Service Bulletin

SB99-71-06

ENGINE EXHAUST TAILPIPE LANYARD INSTALLATION AND FUEL FLOW TRANSDUCER RELOCATION

T206H

Figure 2. Exhaust Lanyard Installation. (Sheet 2)

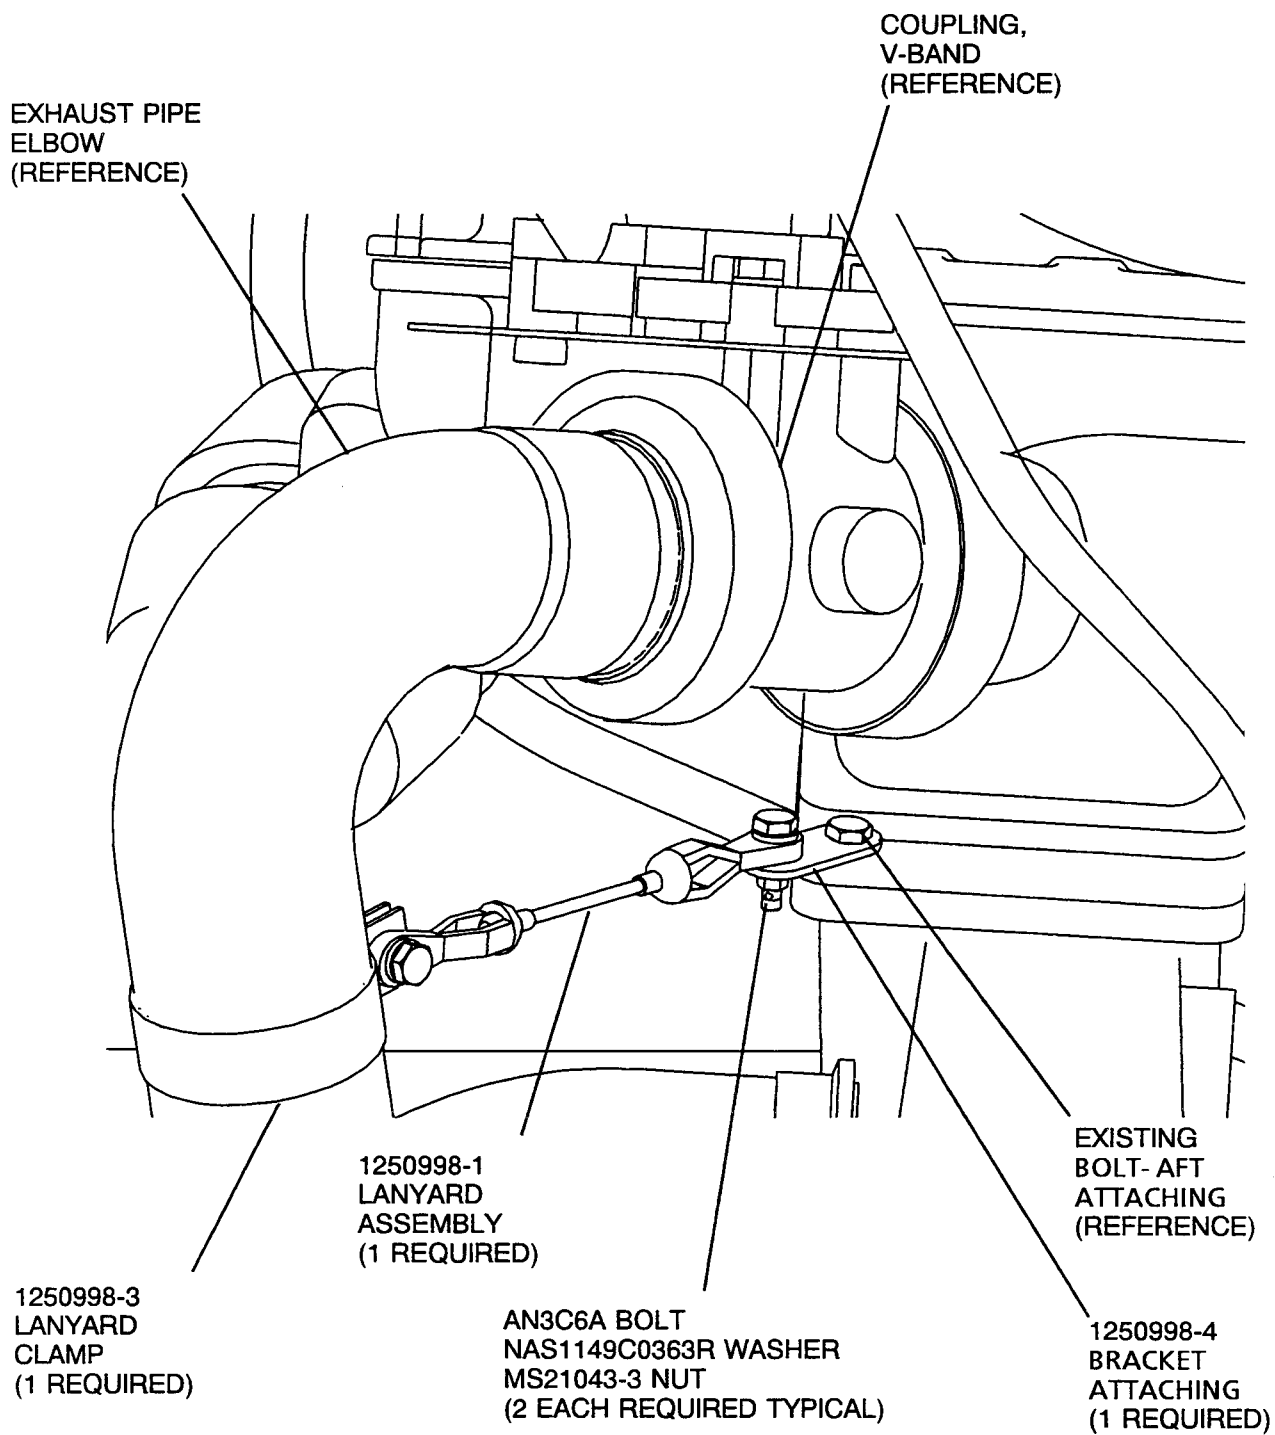
A. (Refer to Figure 3, Sheets 1 and 2) Exhaust lanyard installation:

- (1) Use existing turbocharger attaching hardware (aft outboard attaching bolt) to attach the tailpipe lanyard.

NOTE: Install the 1250998-4 Lanyard Attaching Bracket in place of the upper washer for turbo attachment flange bolt. Torque bolt to 360 inch-pounds after lanyard is positioned.

- (2) Install 1250998-3 Lanyard Clamp around the exhaust pipe elbow and reattach the 1250998-1 Lanyard Cable to the clamp with AN3C6A Bolts, MS21043-3 Nuts and NAS1149C0363R Washers.
- (3) Slide lanyard clamp up the waste gate pipe until lanyard assembly is tight or has reached the bend in the exhaust pipe elbow, and torque the clamp bolt.
